**Addendum No. 01**

Subject: **Mitchell Classroom Modernization Project  
B-037C, B-038C of 2018/19**

Location: **Mitchell Elementary School  
5500 Kingsessing Avenue  
Philadelphia, PA 19142**

**This Addendum, dated February 28, 2019, shall modify and become part of the Contract Documents for the work of this project. Any items not mentioned herein, or affected by, shall be performed strictly in accordance with the original documents.**

**TOILET ACCESSORY SCHEDULE**

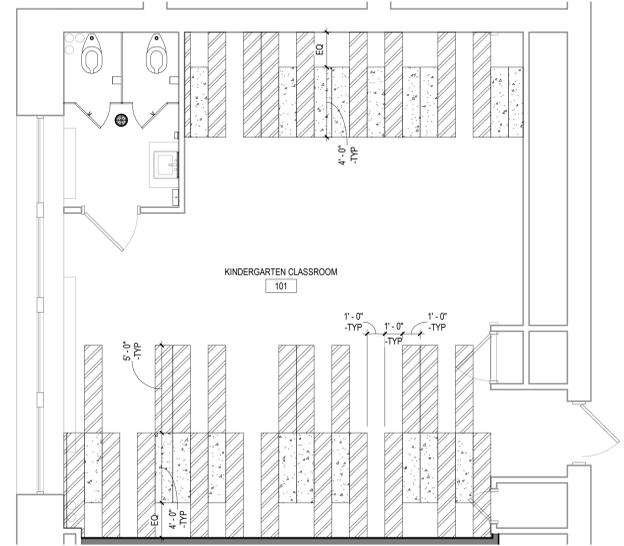
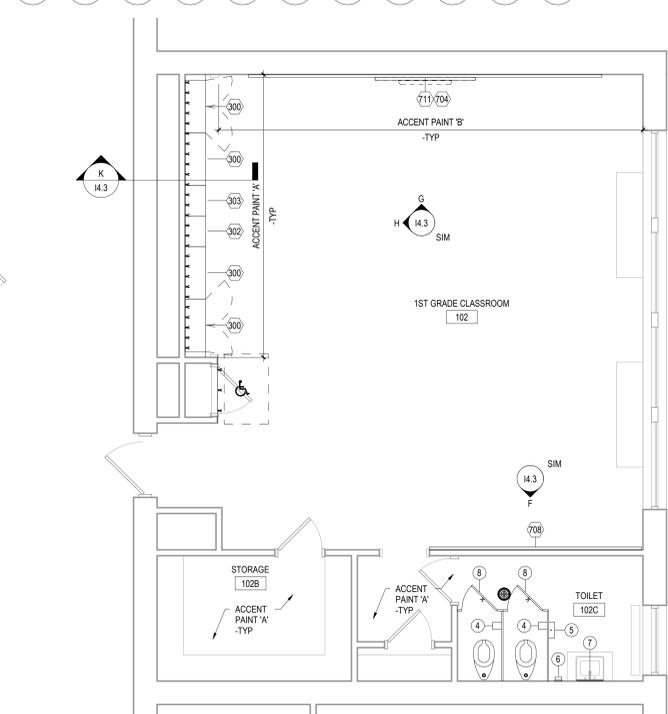
- a. Toilet accessory schedule on I4.1 was modified. Refer to attached drawing.
- b. Details H/I4.3 and K/I4.3 were revised. Refer to attached drawing.
- c. Note regarding "Allowances and Unit Prices" has been removed from E2.1 and E2.2. Refer to attached drawings.
